## **STANDARD DETAILS**

### Modifications To the HRPDC Regional Construction Standard Details

**RESIDENTIAL ENTRANCE**  
**W/OUT CURB & GUTTER**

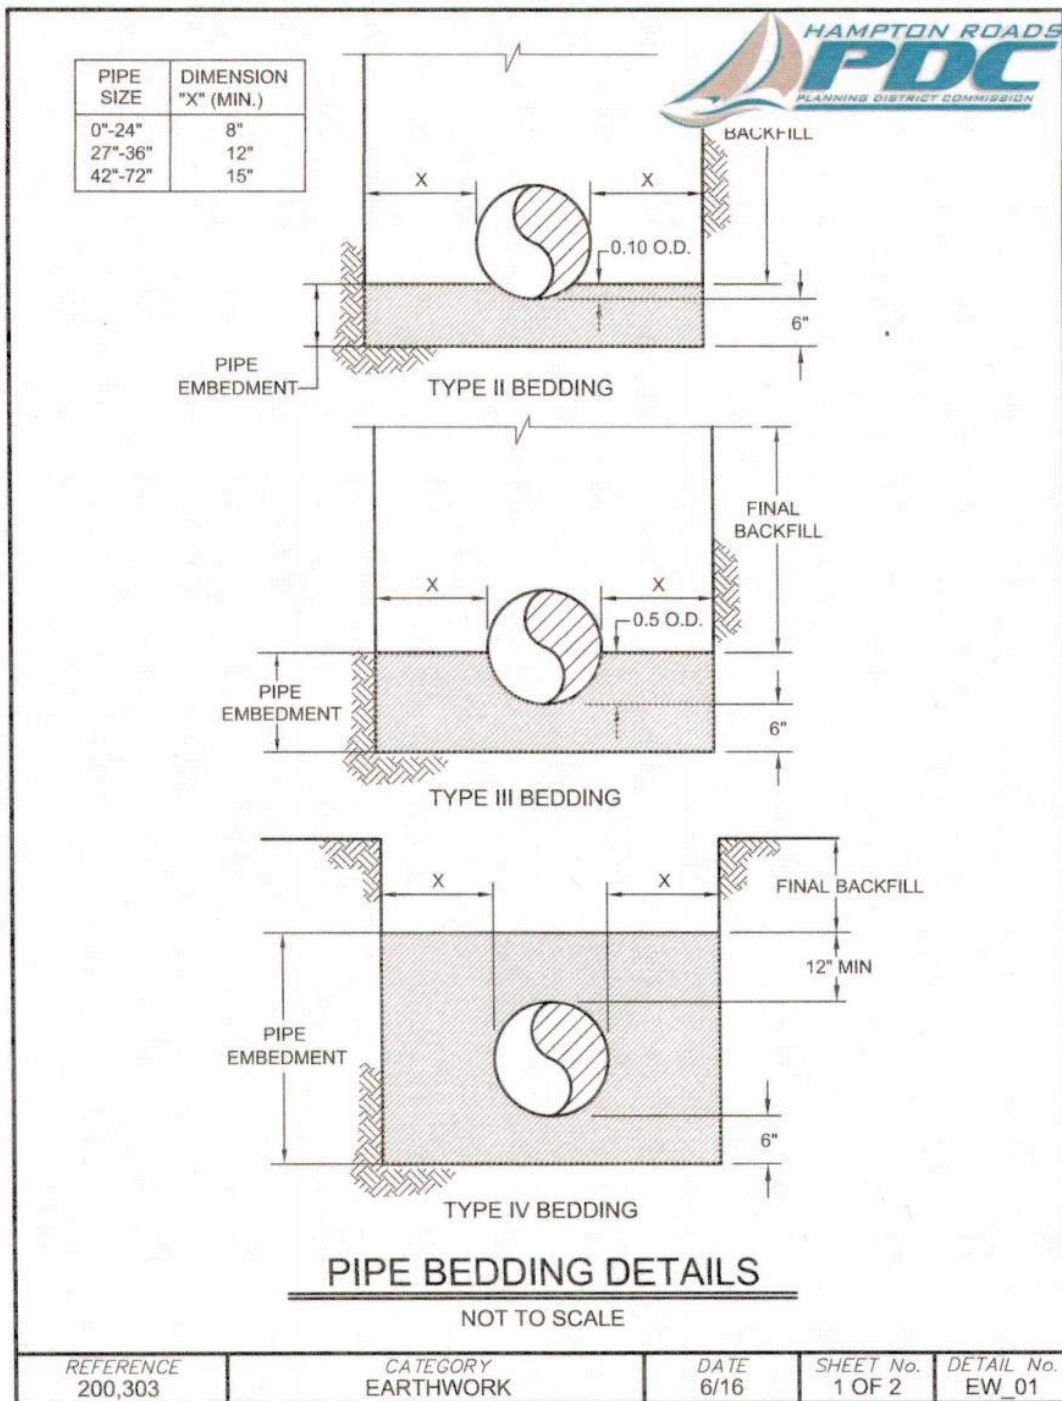
CI-08	Residential Entrance w/out Curb and Gutter	<b>Remove and Replace with:</b> Modified CI_08		
RC-01	Pavement Patching For Flexible Pavement	<b>Delete Notes and Replace with:</b> NOTES: 1.) Minimum pavement sections will be as shown in the attached TABLE 1 – Pavement Design below. 2.) Total utility patch asphalt depth shall be the total asphalt depth shown in TABLE 1 or the total existing pavement depth whichever is greater. Surface asphalt (SM-9.5) of depth shown in TABLE 1.0 shall be provided. 3.) See special provision sections 317.II Execution.2.1 General F thru J and 317.III Measurement for Payment. F. for required extents of restoration. 4.) Backfill to be placed and compacted according to specifications section 303. Backfill shall be select material Type I with a minimum CBR of 20 as specified in the VDOT Road & Bridge Specifications. 5.) Backfill material per specifications section 200.

1. PIPE LOCATION MAY VARY WITHIN THE RIGHT-OF-WAY AS NECESSARY. THE PIPE SHALL BE INSTALLED TO PROVIDE AND/OR MAINTAIN POSITIVE DRAINAGE.
2. PIPE SHALL EXTEND THREE FEET (MINIMUM) BEYOND FARTHEST OUTSIDE EDGE OF ENTRANCE AT CROSSING. PROVIDE COVER OVER PIPE AS SPECIFIED BY ENGINEER.
3. WATER METERS AND SEWER CLEANOUTS SHALL NOT BE LOCATED IN DRIVEWAY (ENTRANCE) OR APRON UNLESS AUTHORIZED BY OWNER.

**STANDARD PRECAST CONCRETE  
MANHOLE W/ EXTENDED MONOLITHIC BASE**

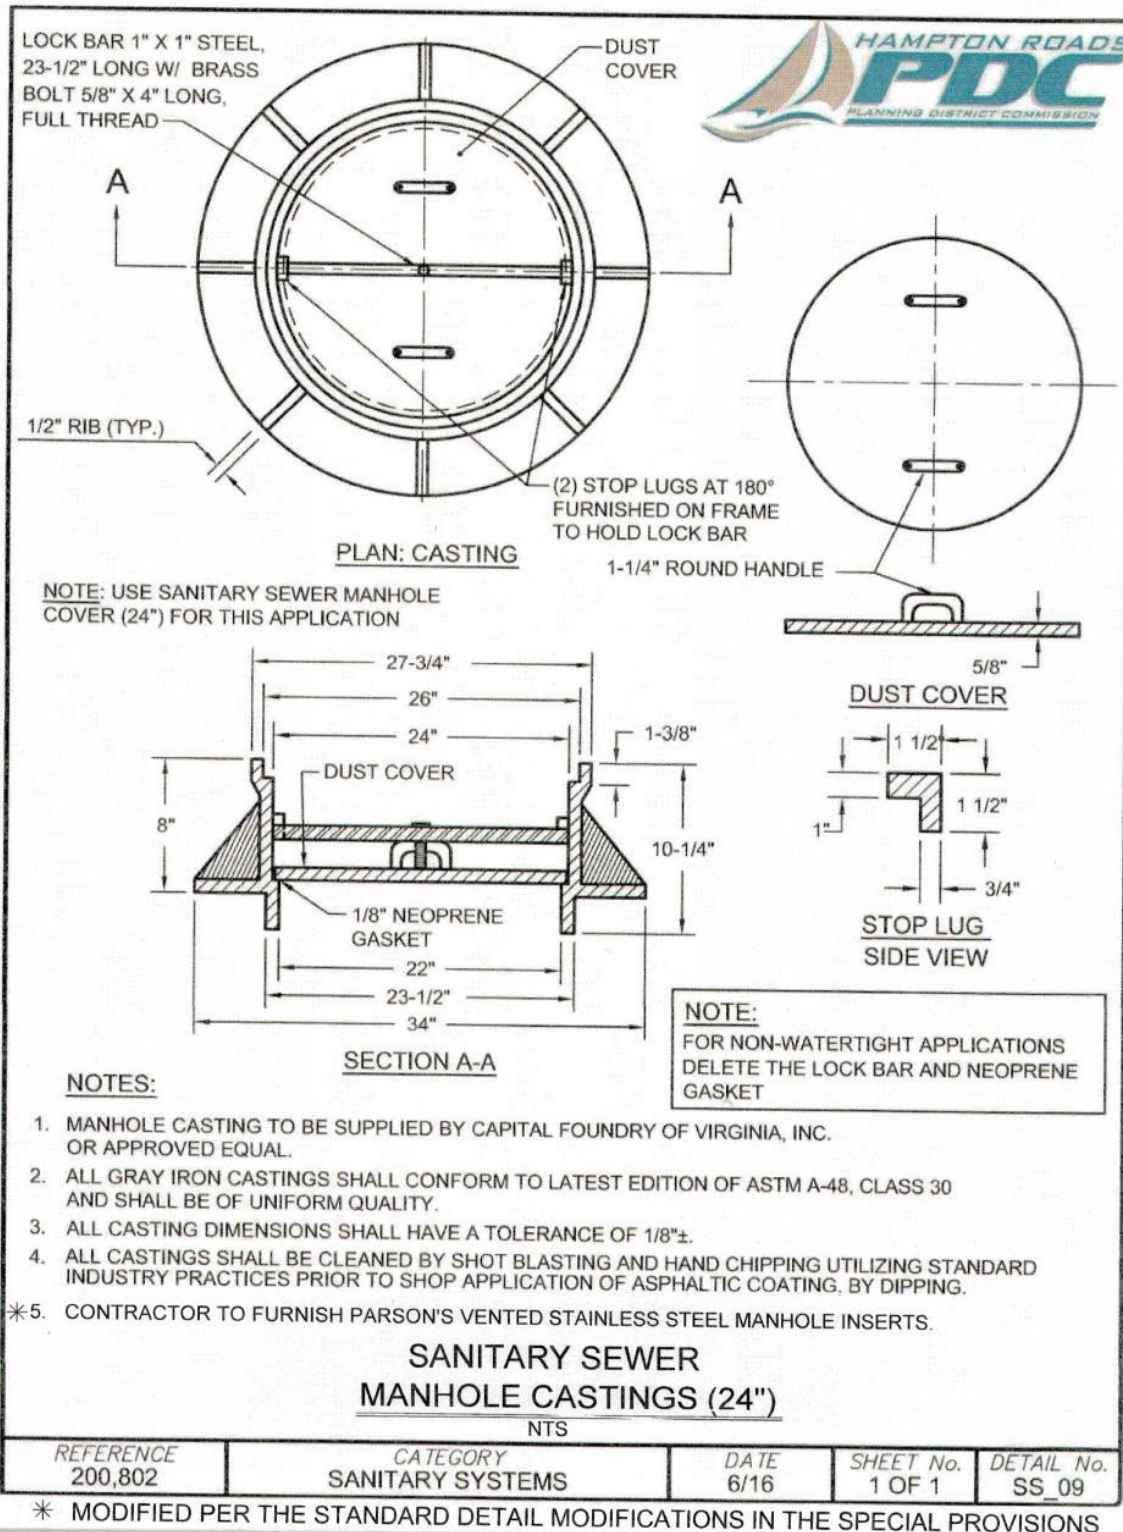
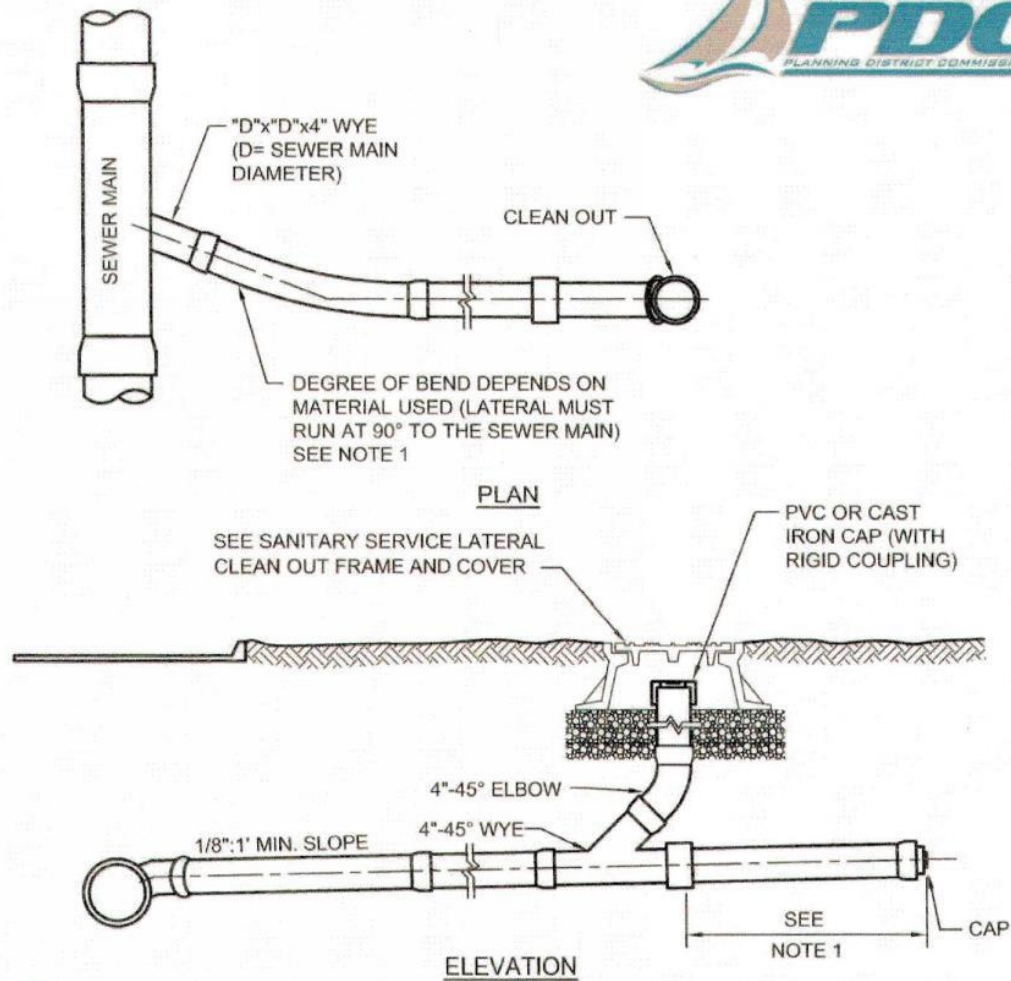
SS-01	Standard Precast Concrete Manhole w/Extended Monolithic Base	<b>Revise:</b> Detail note “Support Pipe and Manhole on 6” Min. of #57 Stone with Woven geotextile fabric. (Greater Depths may be required in poor soils.)” <b>Revise:</b> Note #1 “Precast Concrete Manhole to be in Compliance with ASTM C-478, 4000 psi.” <b>Add Note #6:</b> Conshield additive is required in all concrete. <b>Add Note #7:</b> Manhole steps are not required.
SS-02	Precast Concrete Shallow Manhole	<b>Revise:</b> Detail note “Support Pipe and Manhole on 6”Min. of #57 Stone with Woven geotextile fabric. (Greater Depths may be required in poor soils.)” <b>Revise:</b> Note #2 “Precast Concrete Manhole to be in Compliance with ASTM C-478, 4000 psi.” <b>Add Note #3:</b> Conshield additive is required in all concrete.
SS-03	Sanitary Sewer Straddle Manhole	<b>Revise:</b> Detail note “Support Pipe and Manhole on 6” Min. of #57 Stone with Woven geotextile fabric. (Greater depths may be required in poor soils.)” <b>Revise:</b> Note #1 “Precast Concrete Manhole to be in Compliance with ASTM C-478, 4000 psi” <b>Add Note #4:</b> Conshield additive is required in all concrete. <b>Add Note #5:</b> Manhole steps are not required.

- \* 1. PRECAST CONCRETE MANHOLE TO BE IN COMPLIANCE WITH ASTM C-478 4000 PSI.
- 2. WALL THICKNESS TO BE 5" MINIMUM FOR 48" INSIDE DIAMETER MANHOLES AND 6" MINIMUM FOR 60" INSIDE DIAMETER MANHOLES.
- 3. INSIDE DIAMETER OF MANHOLE MUST INCREASE TO 60" WHEN MANHOLE DEPTH IS GREATER THAN 12 FEET. 60" DIAMETER TO BE CONTINUOUS UP TO CONE SECTION.
- 4. MAXIMUM OF FOUR LATERALS PER MANHOLE.
- 5. IF LATERALS ARE TO ENTER INTO THE ECCENTRIC TAPER UNIT, THEY MUST ENTER ON THE NON-TAPERED SIDE.
- \* 6. CONSHIELD ADDITIVE IS REQUIRED IN ALL CONCRETE.
- \* 7. NO STEPS IN PRECAST SANITARY MANHOLE.

**SANITARY SEWER SERVICE CONNECTION**

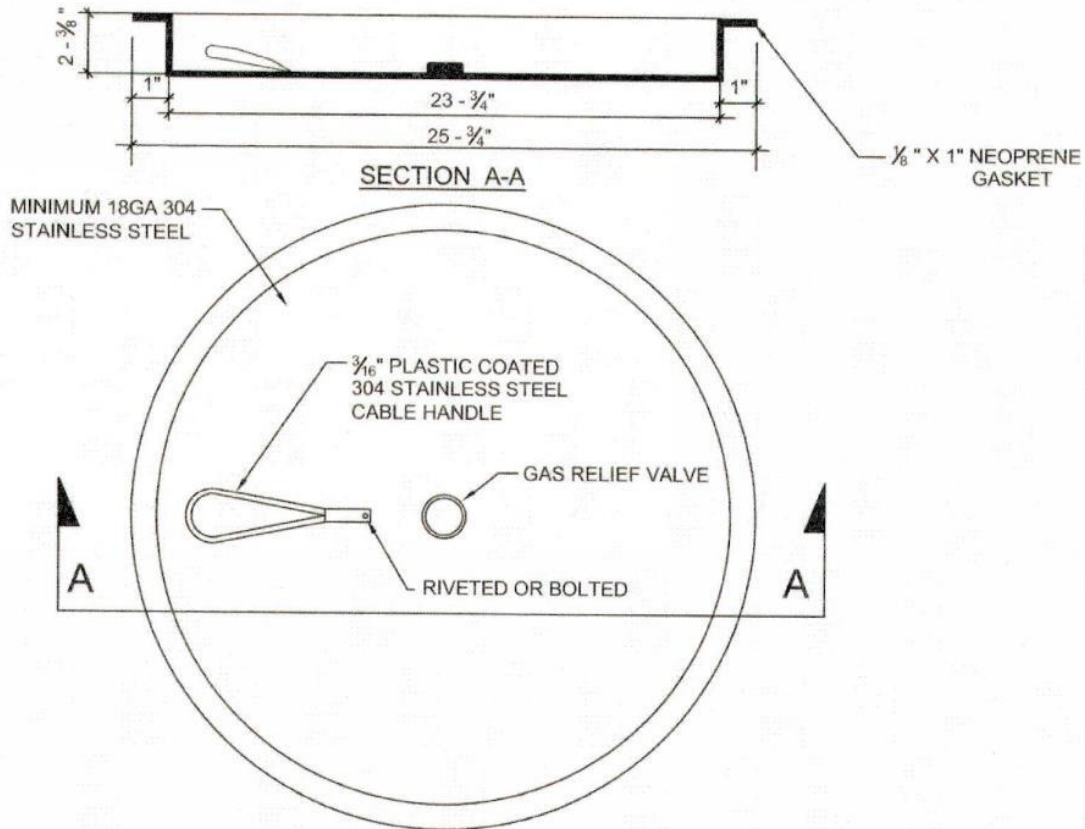
SS-09	Sanitary Sewer Manhole Casting (24”)	<b>Add:</b> Detail note #5: Provide Parson’s vented stainless steel manhole inserts.
SS-11	Sanitary Service Lateral Clean Out Frame and Cover	<b>Add Note:</b> 5. Frame and cover shall be painted fluorescent green.
SS-14	Sanitary Sewer Service Connection	<b>Add Note:</b> 5. Cap shall be PVC and inverted.
SS-16	Deep Sanitary Sewer Service Connection	<b>Revise:</b> Detail note “Compacted #57 Stone.”
SS-17	Force Main Saxophone	<b>Revise :</b> Detail note 3 “Coat Manhole with epoxy per locality requirements ”
SS-19	Manhole Insert	<b>Add:</b> Detail note #6: Provide Parson’s vented stainless steel manhole inserts. Inserts shall fit under the existing dust cover. The outside diameter of the insert shall be 23.5-inches.
